Proposal for Supplement 4 to the 01 Series of Amendments to UN Regulation No. 148 (Uniform provisions concerning the approval of light signaling devices (lamps) for power-driven vehicles and their trailers)

The text reproduced below was prepared by the expert from The Netherlands on behalf of the IWVTA IWG to delete the Unique Identifier (UI) marking provisions. The modifications to the existing text are marked in bold for new and strikethrough for deleted characters.

Figure I — Unique identifier

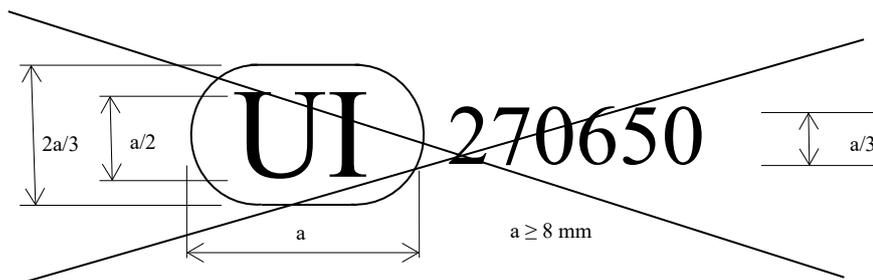
~~3.3.3. Unique Identifier (UI)~~

~~3.3.3.1. The approval marking as defined in paragraph 3.3.2. may be replaced by the Unique Identifier, if available. The Unique Identifier mark shall follow the format in the example shown below~~

~~The above Unique Identifier marked on the lamp shows that the type concerned has been approved and that the relevant information on that type approval can be accessed on the UN secure internet database by using 270650 as the Unique Identifier.~~
